August 10, 2026

RE: Town of Caledon Peer Review of Agricultural Impact Assessment for CBM Caledon Pit/Quarry

CBM Pit and Quarry Proposed Rehabilitation Plan

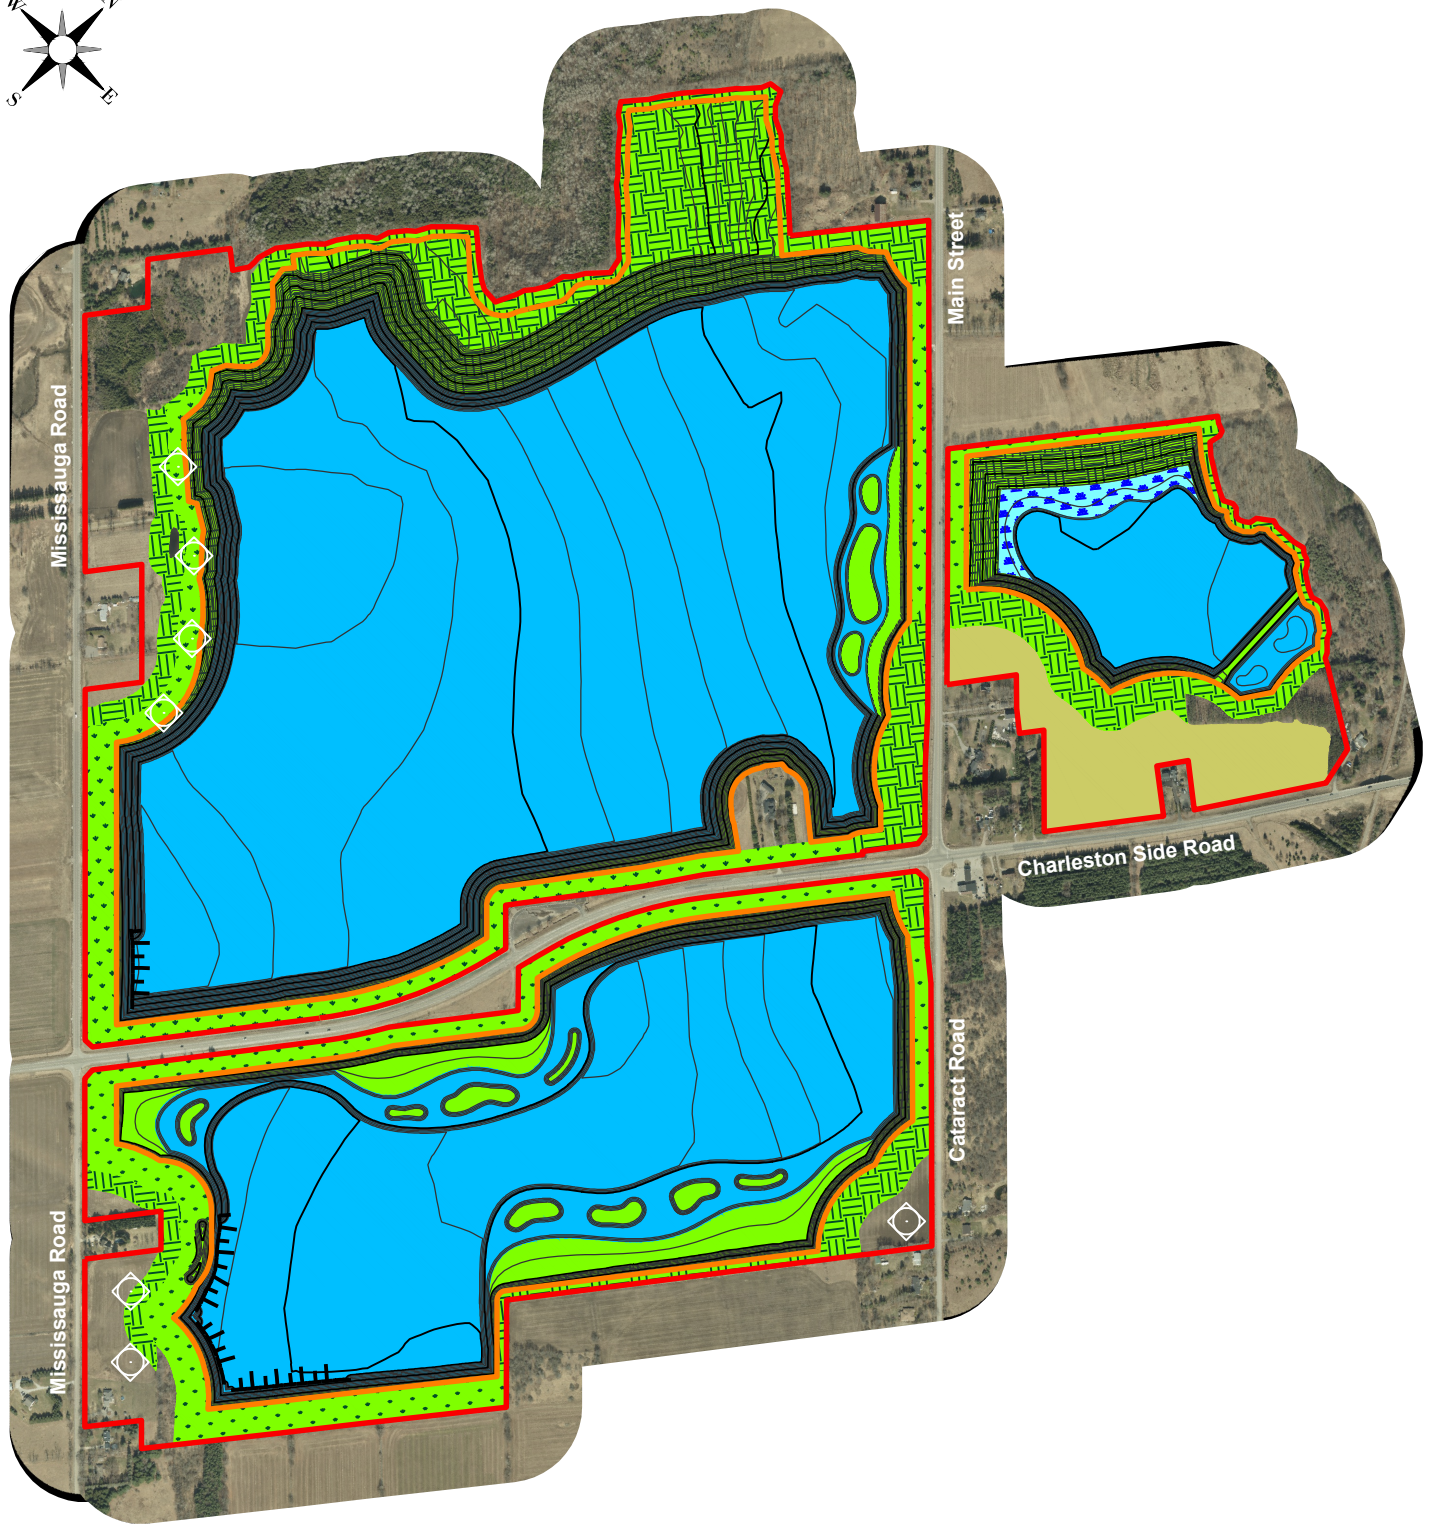
"SAI has reviewed the material submitted by the applicant and notes that:

- a) a soils budget was not provided; and*
- b) soil management measures that result in the separate stripping/stockpiling of topsoil, subsoil and overburden were not provided.*

It is the opinion of SAI that Colville has not provided sufficient information and analysis to assert that agricultural rehabilitation has been maximized in remaining areas. In this regard, SAI disagrees with Colville's interpretation of consistency with the Provincial Planning Statement, 2024 and conformity with the ARA."

The proposed CBM Caledon Pit/Quarry rehabilitation plan has been designed based on a detailed soil budget completed for the site. See attached figure. Each Area of the rehabilitation plan has been designed to utilize the available topsoil and overburden within that Area and CBM has committed to the community to not import excess soils as part of the rehabilitation of the site.

The Main Area includes 546,200 m³ of topsoil and 4,430,000 m³ of overburden for a total of 4,976,200 m³ soils available for the rehabilitation plan. These soils have been utilized to create 2:1 sideslopes around the majority of the Main Area, islands to add ecological diversity and along the northern boundary of the Main Area portions of the site have been restored to existing grade and are being rehabilitated to woodland. The northern boundary is being rehabilitated to a woodland condition since this portion of the site is located in the Greenbelt Natural Heritage System and the Greenbelt Plan promotes reforestation and enhance the ecological connection and corridors in this portion of the site.

The North Area includes 21,500 m³ of topsoil and 300,000 m³ of overburden for a total of 321,500 m³ soils available for the rehabilitation plan. These soils have been utilized to create 2:1 sideslopes around the majority of the North Area and forested sideslopes and wetland areas along the northern boundary to enhance ecological diversity of the site.

The South Area includes 190,300 m³ of topsoil and 670,000 m³ of overburden for a total of 860,300 m³ soils available for the rehabilitation plan. These soils have been utilized to create 2:1 sideslopes around the majority of the South Area and areas of gradual grade and islands to add diversity to the final configuration of the lake.

Please note that the rehabilitation plan as illustrated in the May 2026 Aggregate Resources Act (ARA) site plans includes a deficit of approximately 600,000 m³ of soils of which 480,000 m³ is located in the South Area. MHBC will be updating the ARA site plans to include minor adjustments to the sidesloping and a reduction of a few of the islands to ensure that the site is designed to achieve a soil balance budget and not result in the importation of excess soils.

As a result of the available soils on-site, the depth of extraction, CBM's commitment to not import excess soils and the requirements of the Greenbelt Plan for natural heritage restoration, there are no available soils to complete agricultural rehabilitation at the site.
